ADDENDUM NO. 1
TO
EXETER, NEW HAMPSHIRE
CONTRACT NO. 1 – WASTEWATER TREATMENT FACILITY UPGRADES
NHDES SRF PROJECT NO. CS-330130-15

JANUARY 2017

ADDENDUM NO. 1

CONTRACT NO. 1 – WASTEWATER TREATMENT FACILITY UPGRADES

TYPICAL ACCESS ROAD SECTION

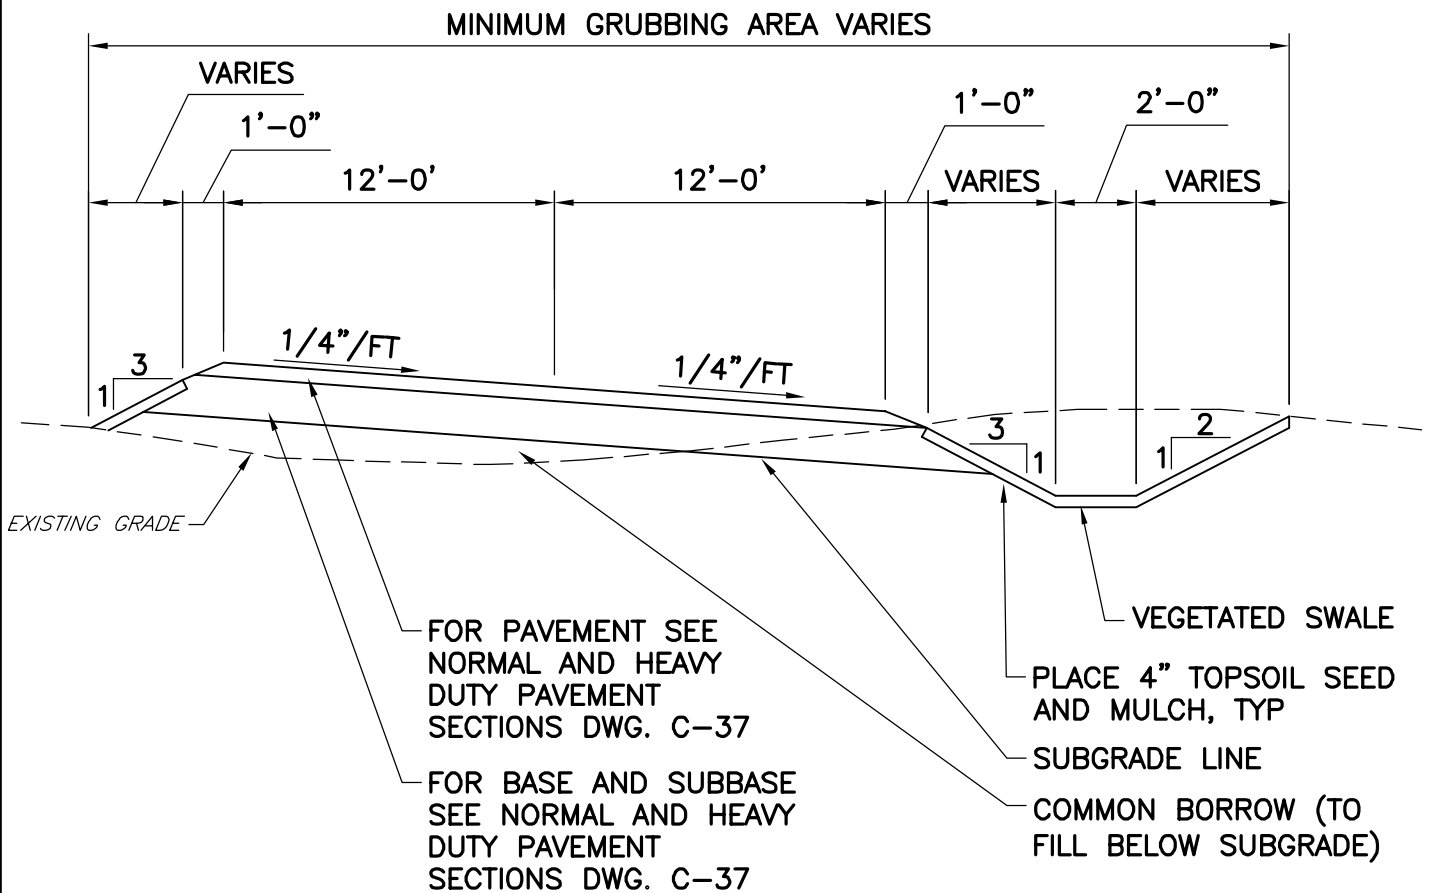
4. Drawing C-32, TYPICAL ACCESS ROAD SECTION: **DELETE** the detail in its entirety and **REPLACE** with the attached TYPICAL ACCESS ROAD SECTION shown on Figure C1.

EXETER, NEW HAMPSHIRE CONTRACT NO. 1 WASTEWATER TREATMENT FACILITY UPGRADES		PROJ NO: 12883	DATE: JANUARY 2017	APP'D		FIGURE: PR1
WRIGHT-PIERCE Engineering a Better Environment				DRAWN BY: APC	EJL	
REVISIONS		DETAIL TEXT CLARIFICATION				
NO.	1	2	3			
				ADDENDUM NO. 1 REFERENCE: DWG PR-26

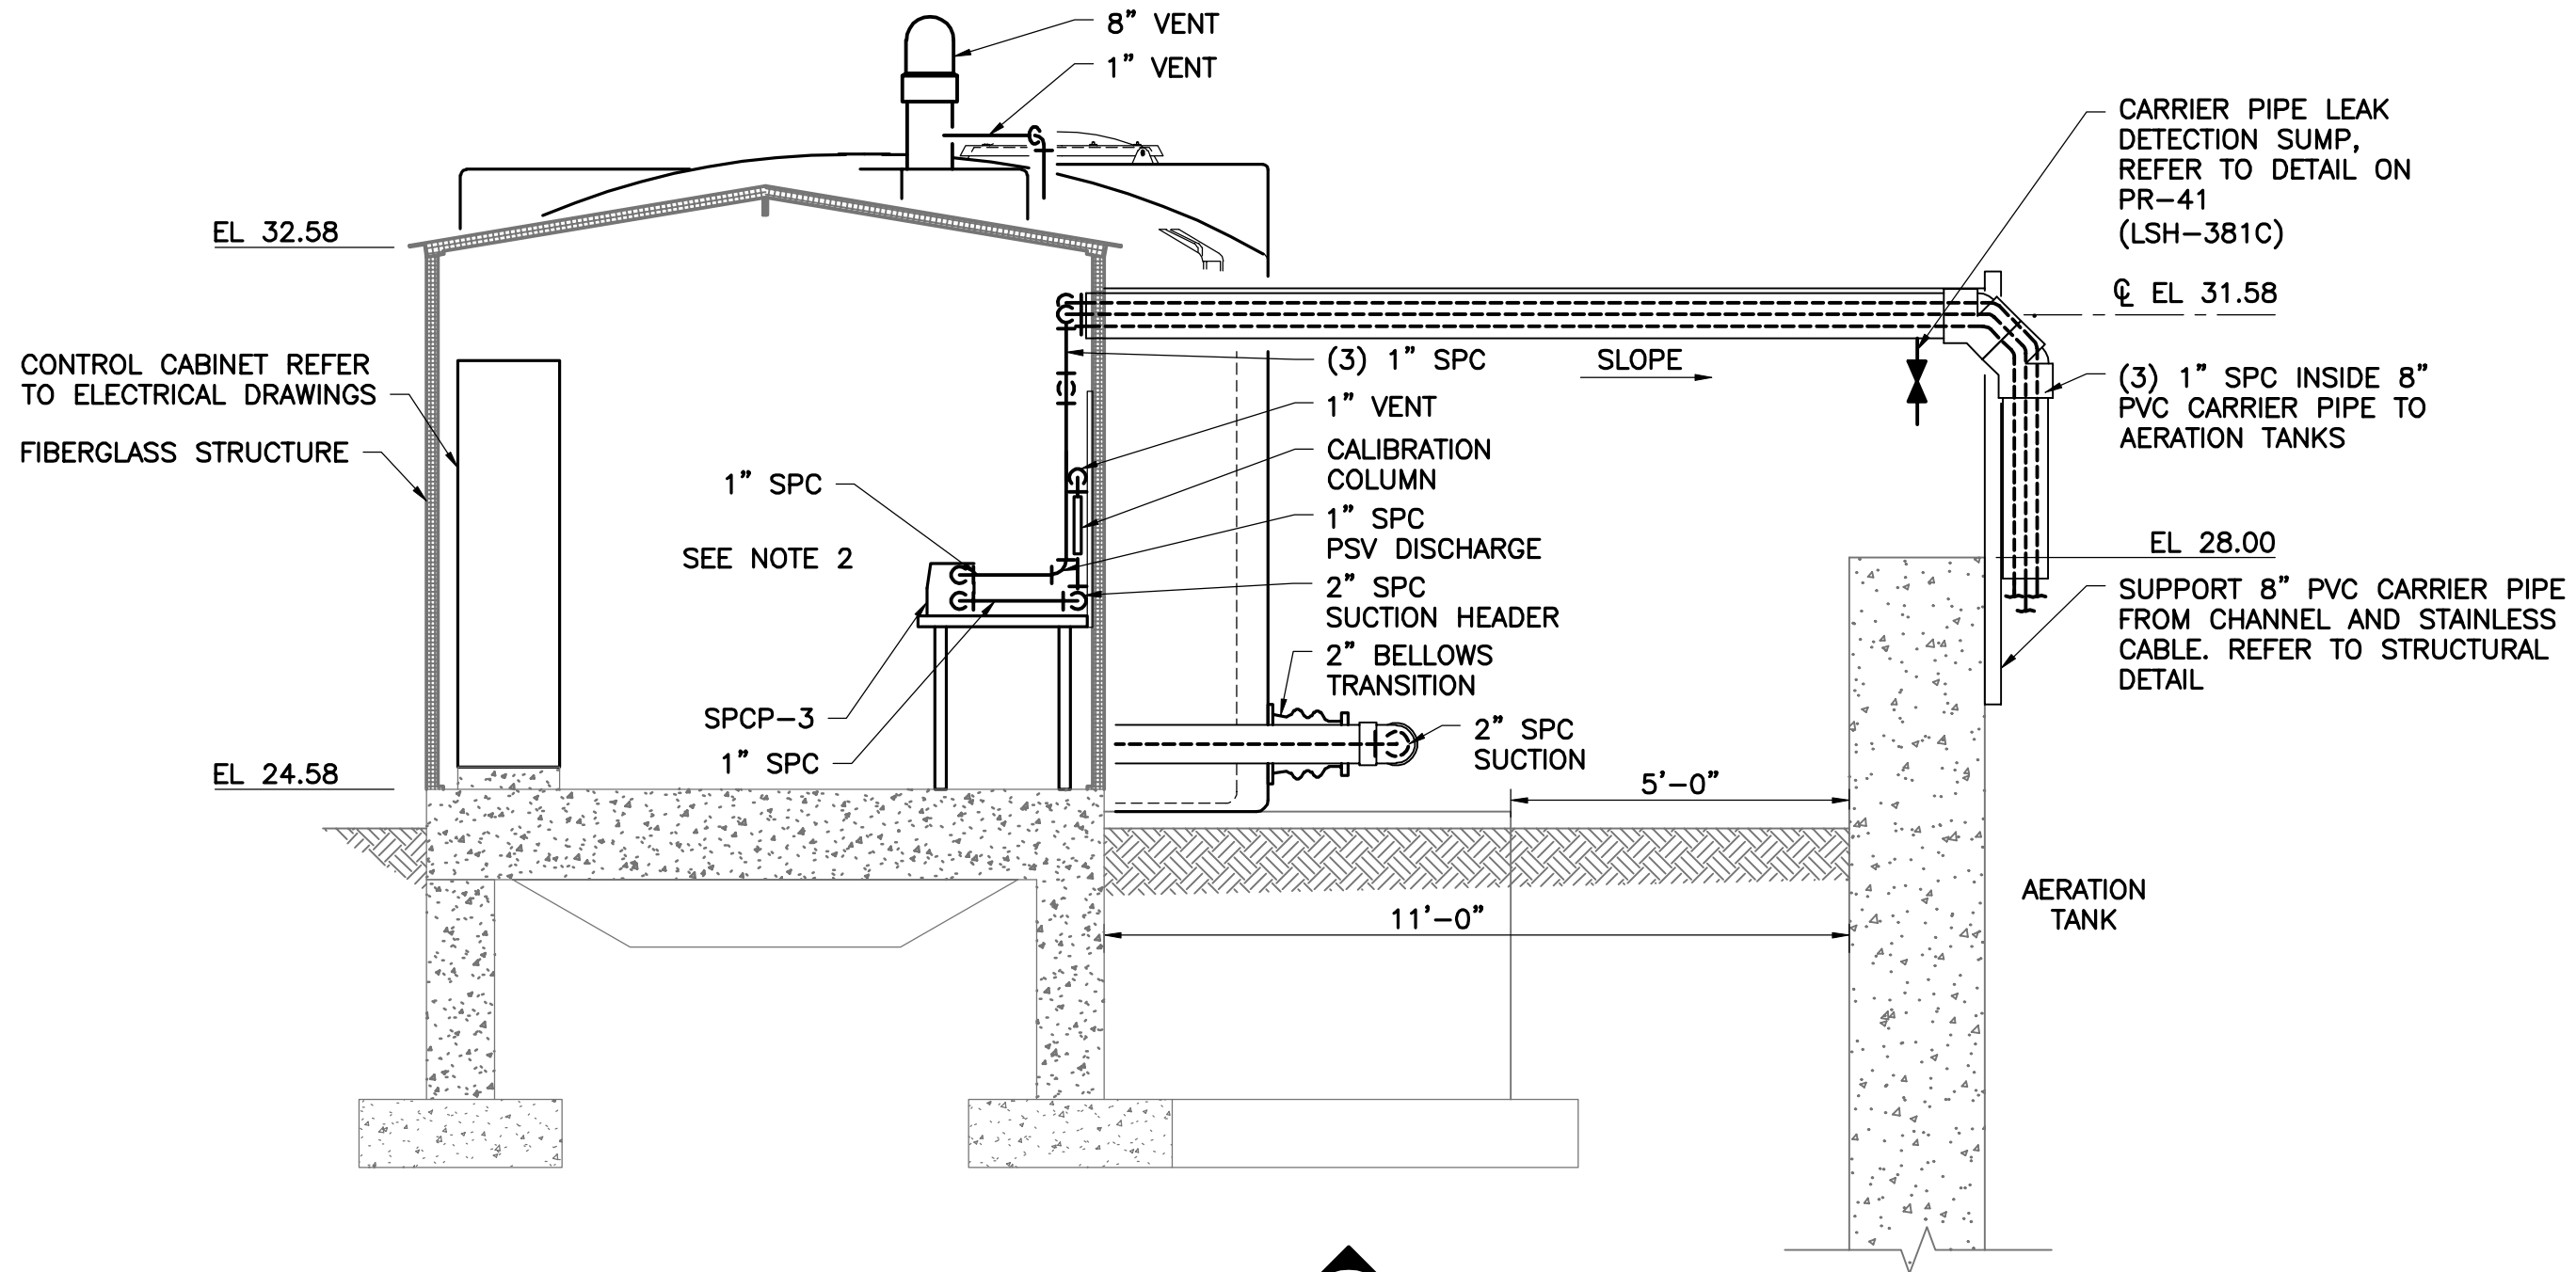
12. Drawing PR-26, SUPPLEMENTAL CARBON AREA PLAN AND SECTIONS: See attached Figure PR1 for text clarification to Section 2.
13. Drawing E-4: **DELETE** Note 10 in its entirety and **REPLACE** with the following: “10. ELECTRICAL DUCTBANK LOCATIONS HAVE BEEN SHOWN SCHEMATICALLY. CONTRACTOR SHALL FIELD COORDINATE SITE PIPING, UTILITIES AND STRUCTURES WITH THE ELECTRICAL DUCTBANKS AND ANY CONFLICTS SHALL BE ADDRESSED VIA RFI PRIOR TO INSTALLING PIPES, STRUCTURES AND DUCTBANKS. ONCE INSTALLATION STARTS, ADJUSTMENTS TO ADDRESS CONFLICTS SHALL BE AT NO COST TO THE OWNER. FINAL DUCTBANK LOCATION SHALL BE COORDINATED WITH THE ENGINEER.”
